CITY OF  
**West Linn**

**PLANNING MANAGER DECISION**

FILE NO.: DR-23-10/FMA-23-04

REQUEST: Approval of a Class I Parks and Natural Area Design Review and Flood Management Area Permit at Maddax Woods Park, 5785 River St

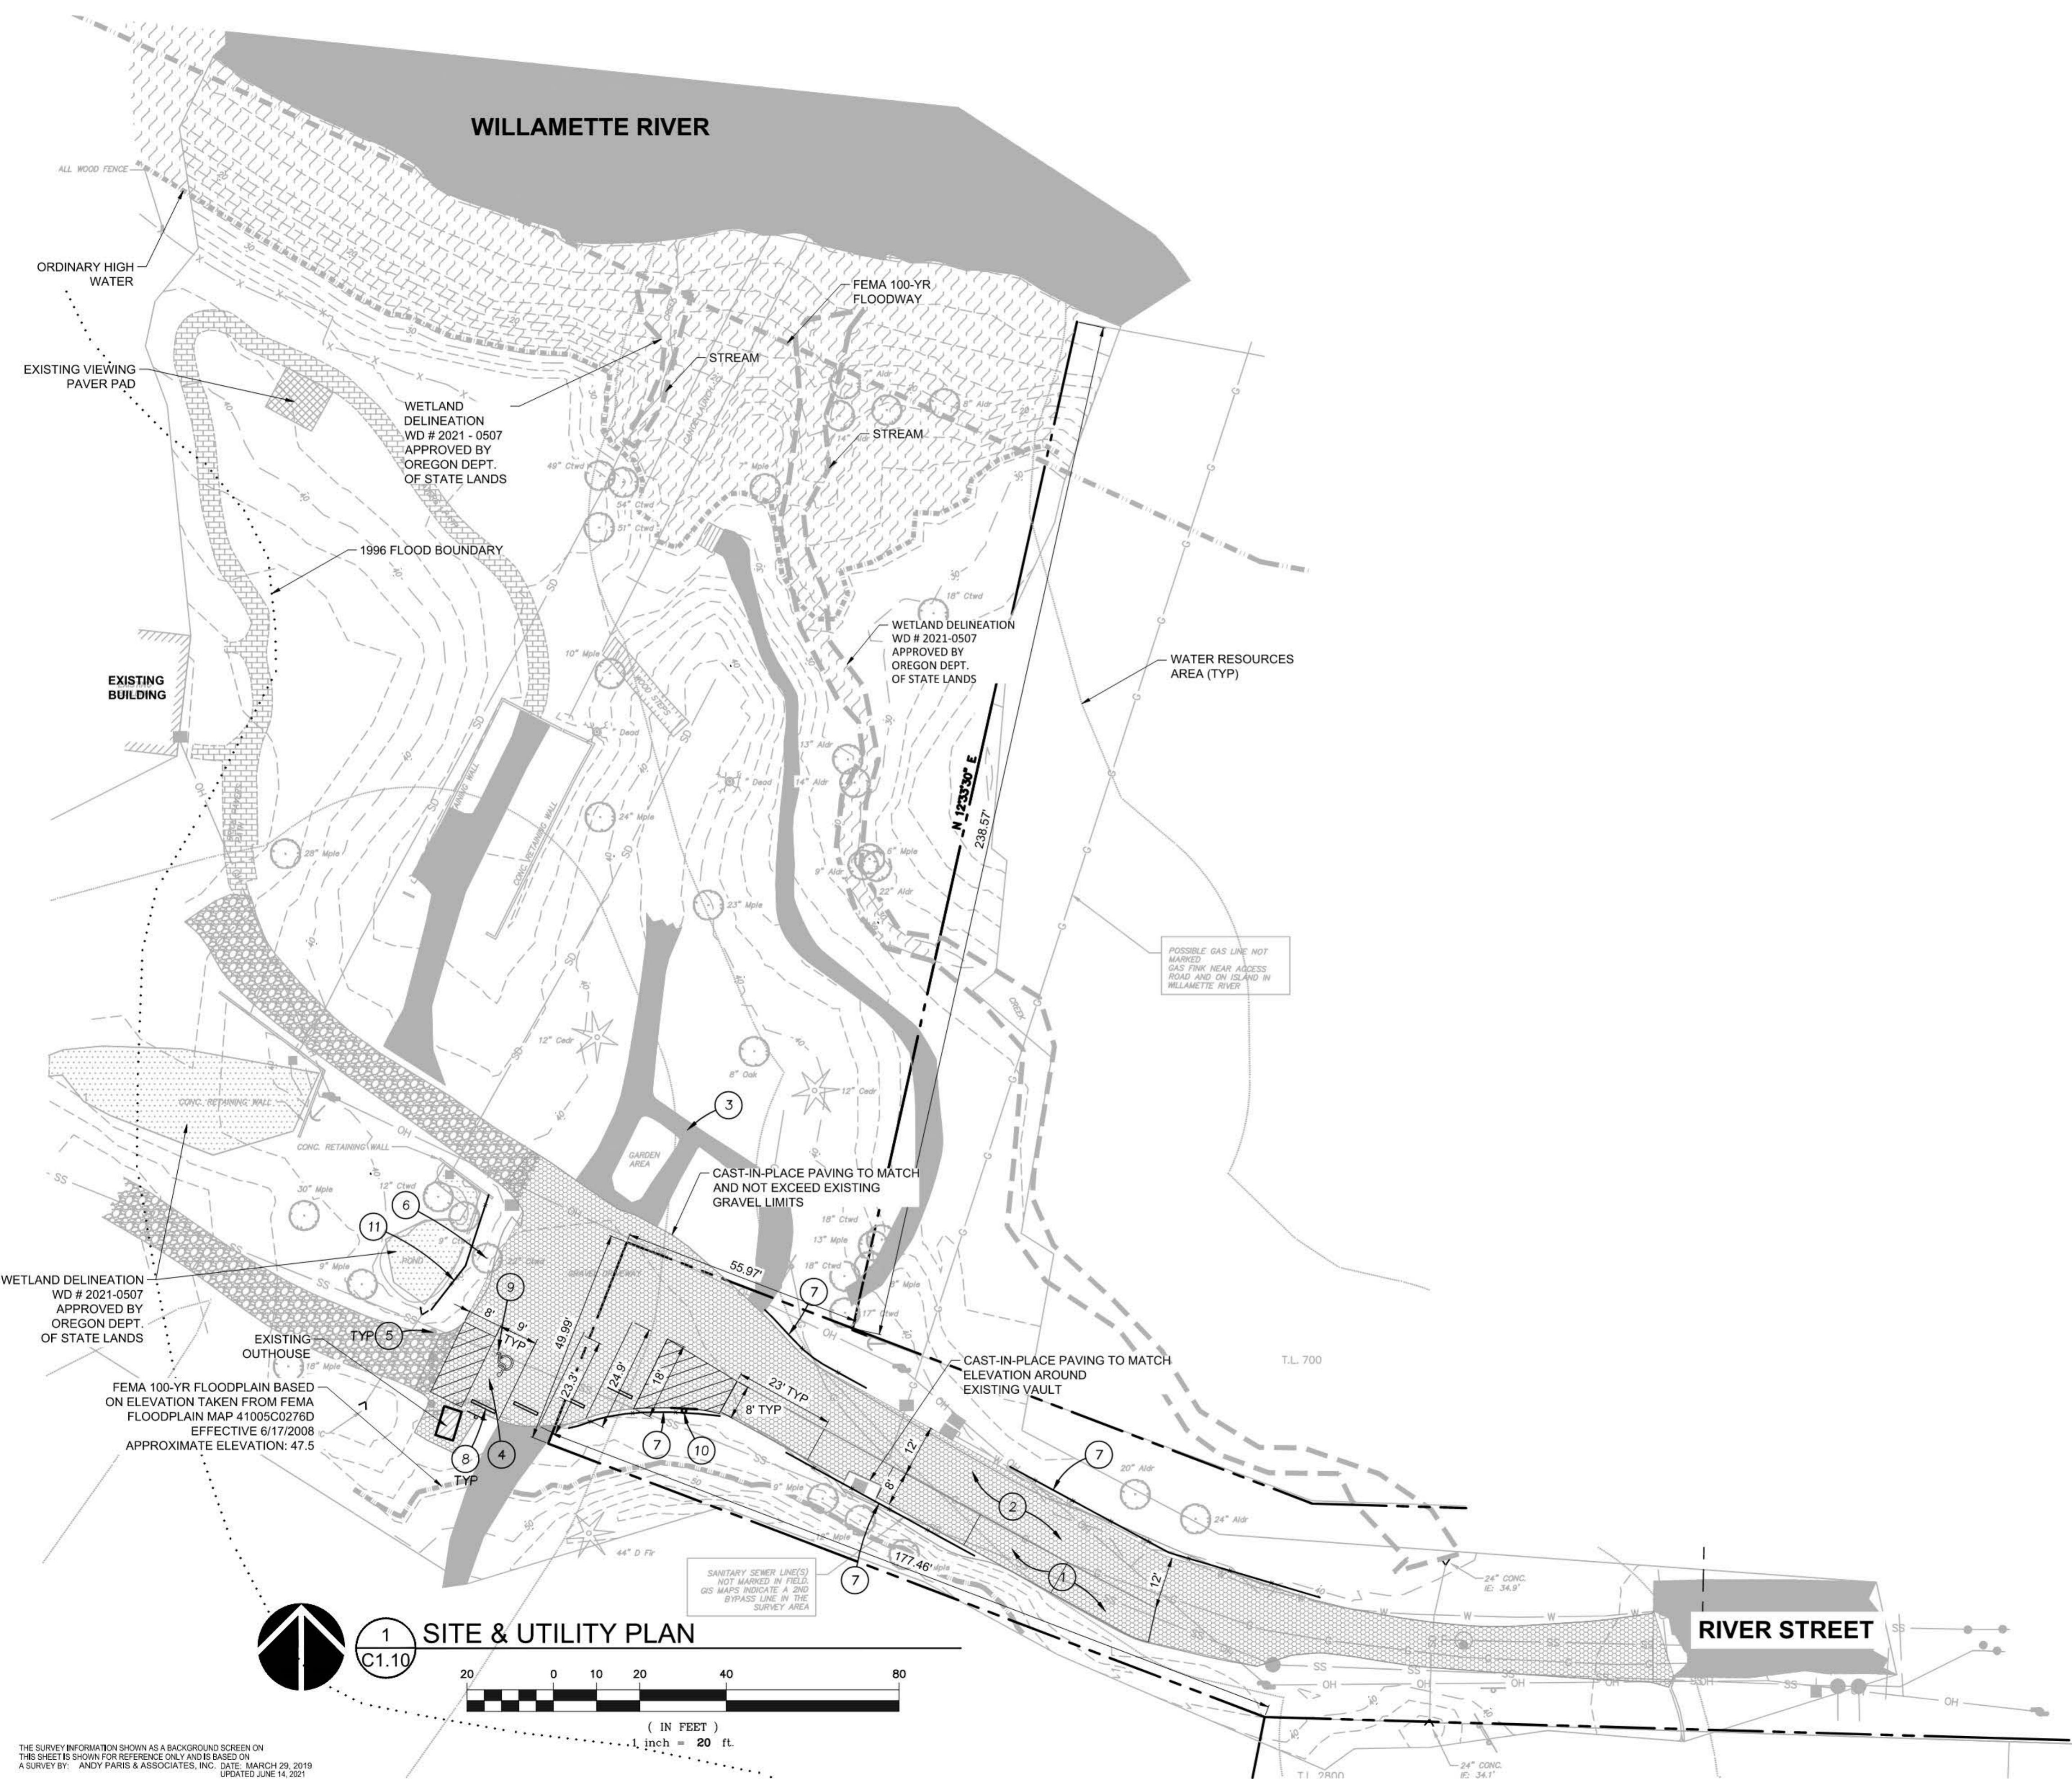
**Staff Finding 36:** Staff adopts applicant findings found in Exhibit PD-1, page 22. Parking spaces are within the Water Resource Area, and per this standard the mix of parking may be modified to allow up to 100% compact spaces so long as required ADA spaces are provided. The applicant has provided plans as part of their submittal that meet the given requirements. See sheet C1.10 of Exhibit J within Applicant Submittal PD-1. The criteria are met.

**Staff Finding 37:** Staff adopts applicant findings found in Exhibit PD-1, page 22. See sheet C1.10 of Exhibit J. The criteria are met.

**Staff Finding 43:** Staff adopts applicant findings found in Exhibit PD-1, page 24. See sheet C1.10, Exhibit J of Applicant Submittal PD-1. The criteria are met.

**Staff Finding 47: Staff adopts applicant findings found in Exhibit PD-1, page 25. The existing parking area comprises 16% of the frontage along the River St right-of-way. See sheet C1.10 of Exhibit J within Applicant Submittal PD-1. The criteria are met.**

**Staff Finding 48: Staff adopts applicant findings found in Exhibit PD-1, page 25 and sheet C1.10. As there are a total of eight parking spaces within this parking area, the criteria do not apply.**

SHEET:  
**C1.20**

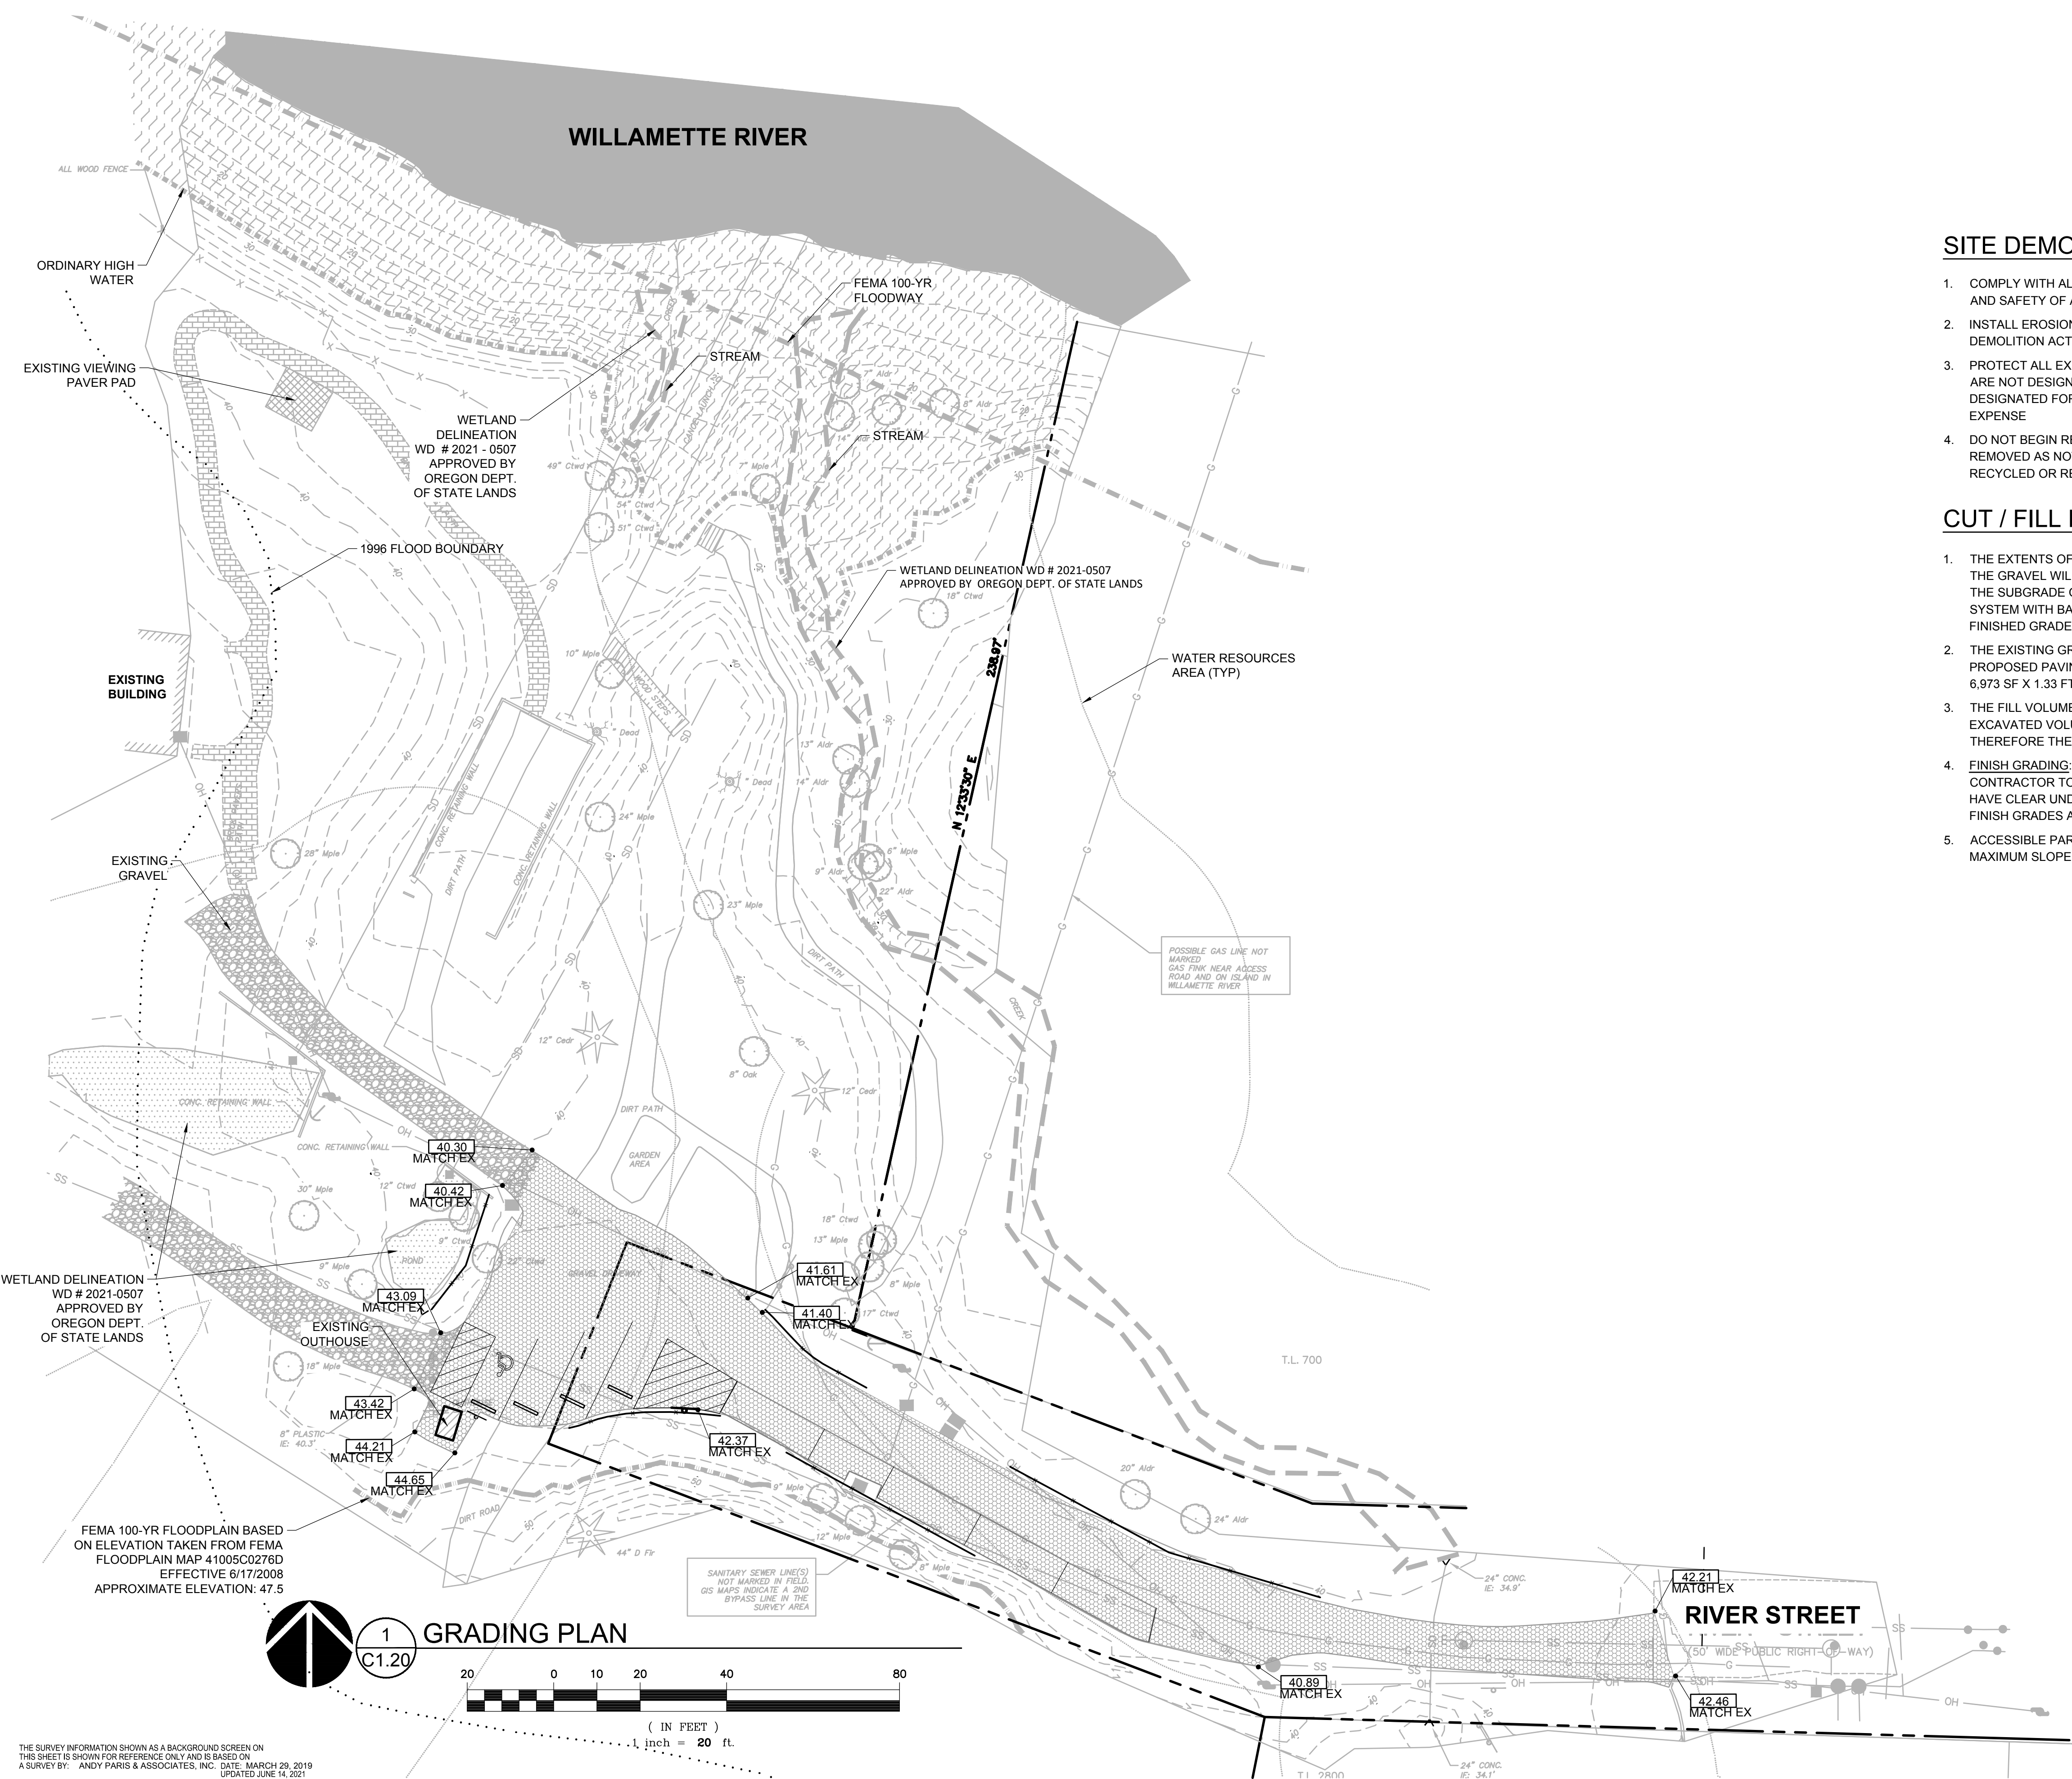
**Staff Finding 5: Staff adopts applicant findings found in Exhibit PD-1, page 7. No buildings are proposed in the special flood hazard area. Replacement of existing gravel with pervious paving is proposed with no change in area or volume of fill per Exhibit PD-1 grading plan sheet C1.20. The criteria are met.**

**Staff Finding 16: Applicant has provided balanced cut and fill calculations. See Exhibit PD-1 sheet C1.20 of the parking improvements plan and the stamped cut and fill memo on page 121. The criteria are met.**
